Model: Model R-C5	Date: 31-Jan-08	No.: RD017001
--------------------------	-----------------	---------------

Subject: Firmware Release Note: Font Exp		Prepared by: Yuji Mimura	
From: 2nd Tech. Support Sec. Service Support Dept.			
Classification:	<input type="checkbox"/> Troubleshooting	<input type="checkbox"/> Part information	<input type="checkbox"/> Action required
	<input type="checkbox"/> Mechanical	<input type="checkbox"/> Electrical	<input type="checkbox"/> Service manual revision
	<input type="checkbox"/> Paper path	<input type="checkbox"/> Transmit/receive	<input type="checkbox"/> Retrofit information
	<input checked="" type="checkbox"/> Other ()

Model: R-C5	Date: 26-Dec-07	No.: RD017002f
-------------	-----------------	----------------

Subject: Firmware Release Note: Fax		Prepared by: T. Hirakawa	
From: 2nd Tech Service Sect., MFP/Printer Tech Service Dept.			
Classification:	<input type="checkbox"/> Troubleshooting	<input type="checkbox"/> Part information	<input type="checkbox"/> Action required
	<input type="checkbox"/> Mechanical	<input type="checkbox"/> Electrical	<input type="checkbox"/> Service manual revision
	<input type="checkbox"/> Paper path	<input type="ch

Interpose the following descriptions between 11 and 12.

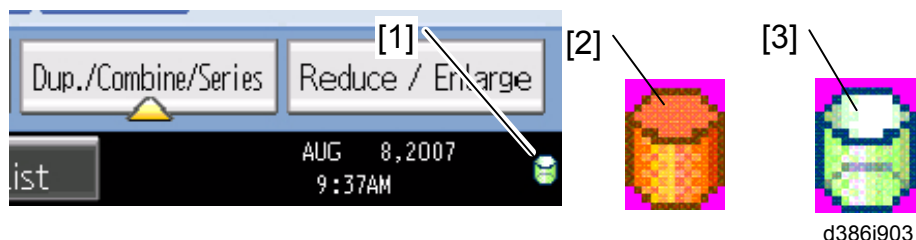
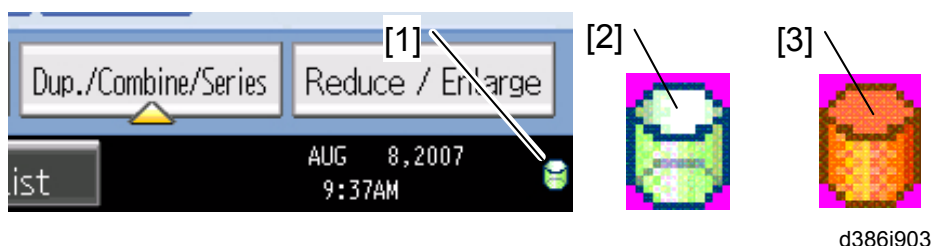
Correct:

Make sure the ROM number and firmware version in area [a] of the diagnostic report are the same as those in area [b].

- [a]: "ROM Number/Firmware Version" – "HDD Format Option"
- [b]: "Loading Program" - "GW5a_zoffym"

Check the accessories and their quantities against the table below.

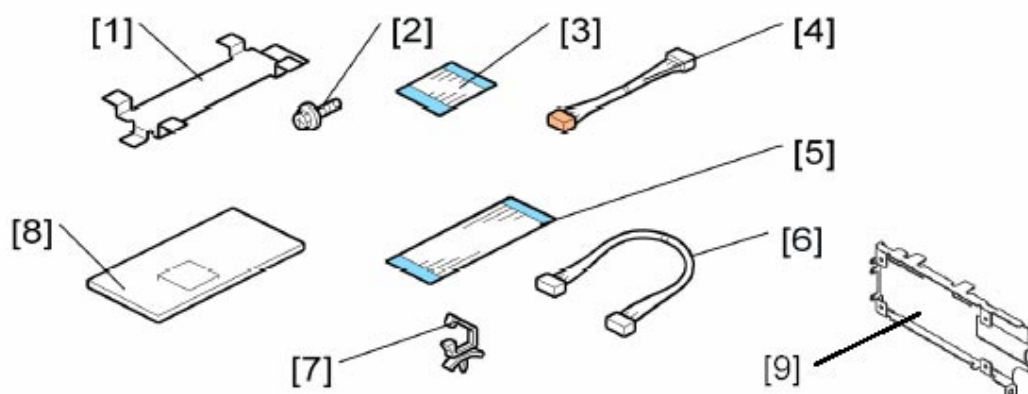
Add the bracket to the list and illustration.

No.	Description	Quantity
1	Bracket (Not used for the B205/D007 series copiers)	1
2	Screws	4
3	FFC (Short) (Not used)	1
4	Harness (Not used)	1
5	FFC (Long)	1
6	Connection Cable	1
7	Harness Clamp	1
8	ICIB	1
9	Bracket	1

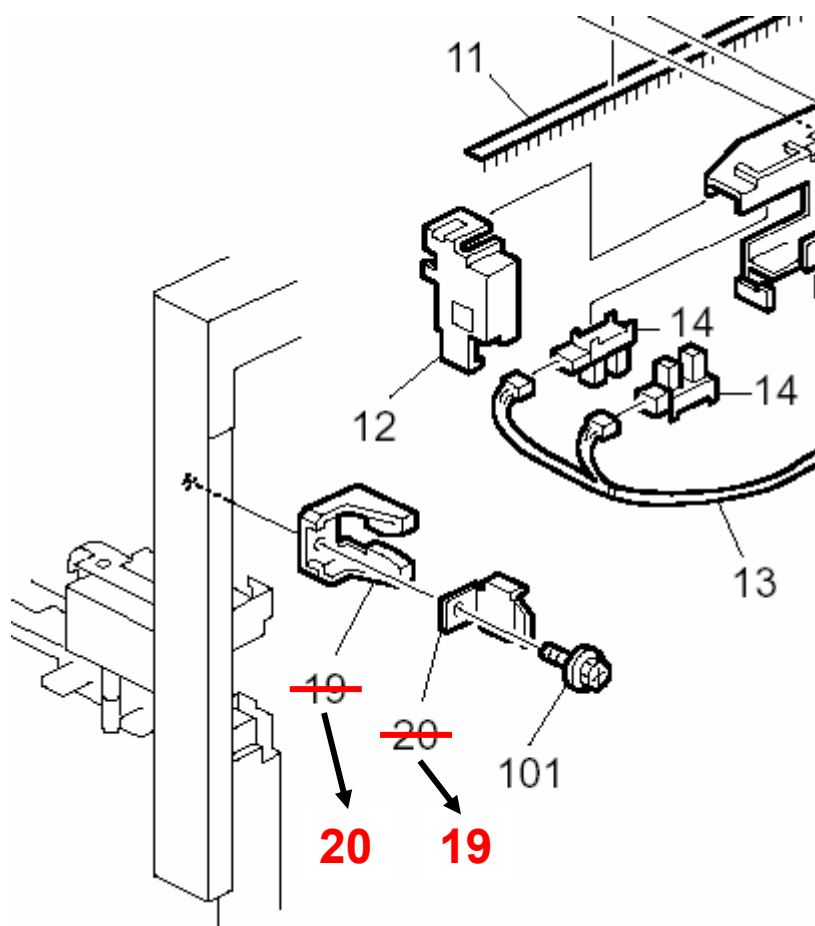
The parts catalog was corrected as follows:

part number	Description	Page	Wrong Index	Correct Index	Note
D0191058	Bracket: Stopper	43	19	20	
D0191059	Guide: Stopper	43	20	19

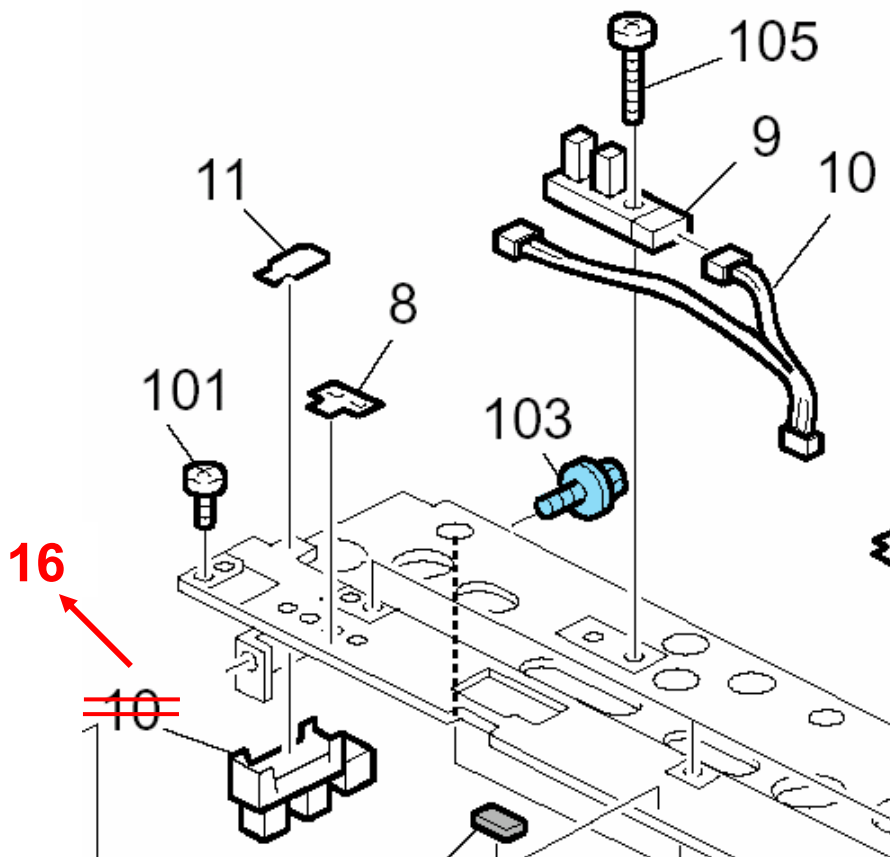
The Parts Catalog was corrected as follows:

part number	Description	Page	Wrong Index	Correct Index	Note
AW020145	Photointerruptor: Flat	15	10	16

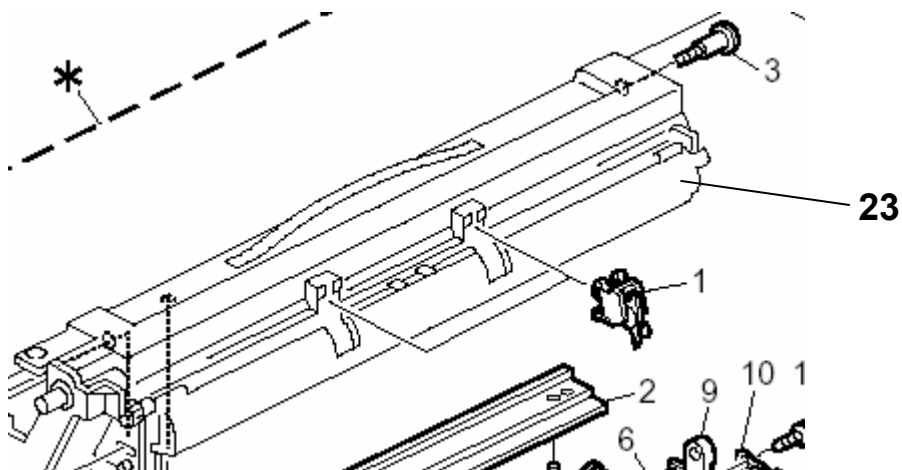
The following part was newly added as per field request:

Old part number	New part number	Description	Q'ty	Int	Page	Index	Note
	B0392343	Drum Shutter	0-1		35	23

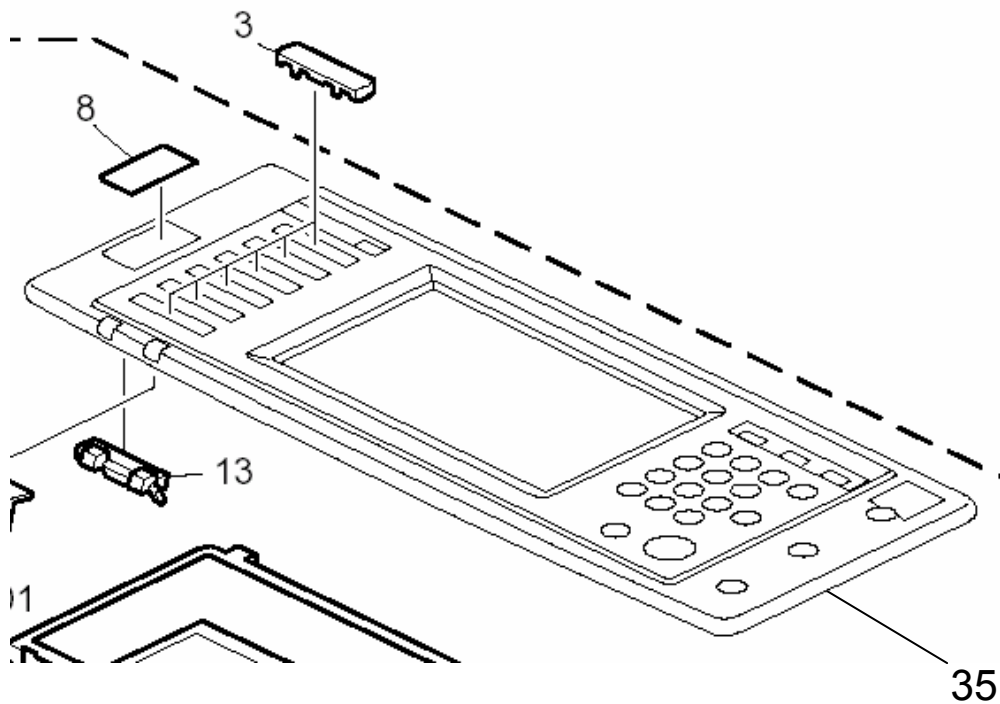
As per field request, the following part was newly added as a service part.

Old part number	New part number	Description	Q'ty	Int	Page	Index	Note
	D0091551	Cover: Upper: NA (NA/AA)	1		13	35	
	D0091501	Cover: Upper (EU/TWN/CHN)	1		13	35

Solution

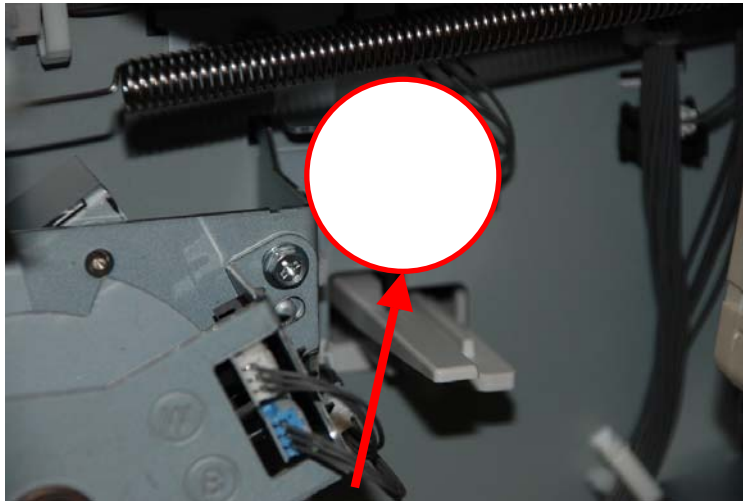
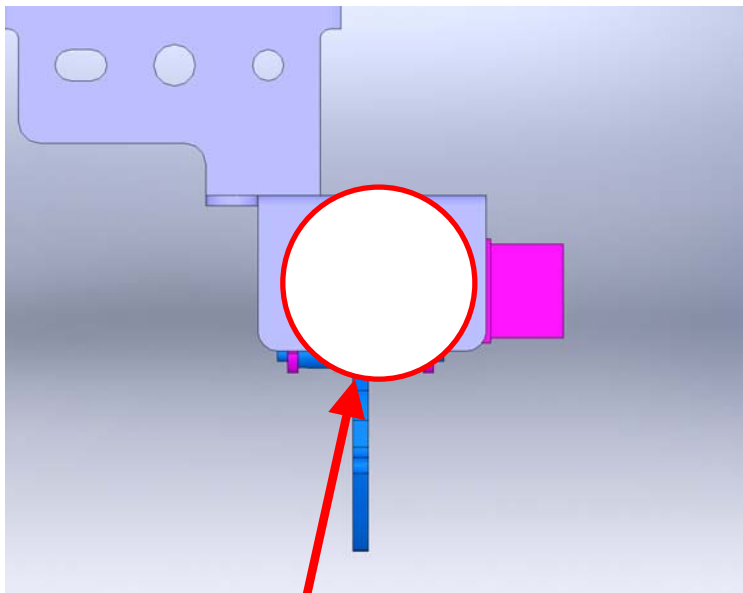
Attach the following Mylar to the bracket (opposite side of the sensor)

For Base Machines: D0192796 (SHEET: PAPER SIZE SENSOR:SIDE FENCE)

3. If the sensor is not attached to the bracket correctly, reattach it to the bracket.
4. Attach the Mylar to the bracket as shown below.

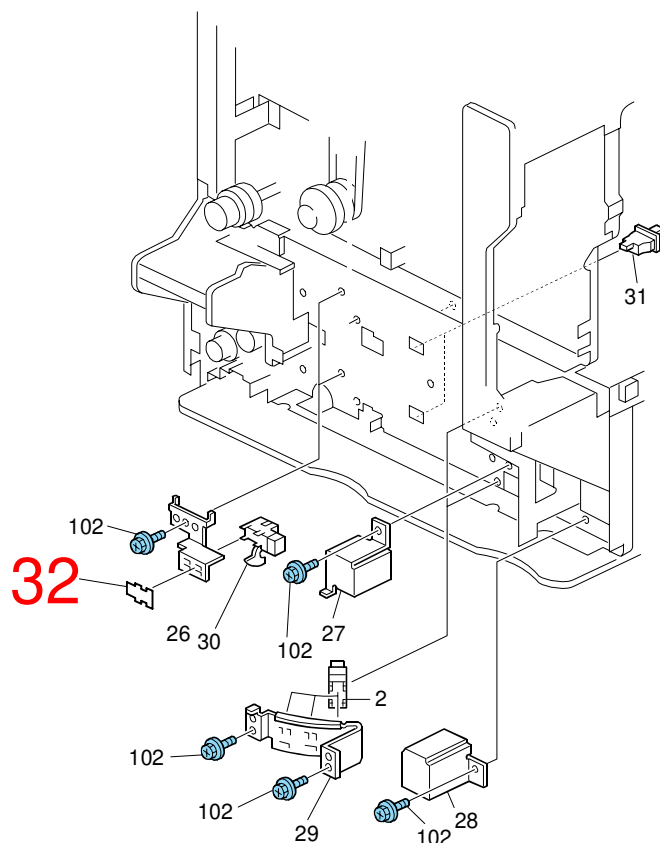
Change: A Mylar was added to the bracket.

Reason: To hold the sensor to the bracket more strongly.
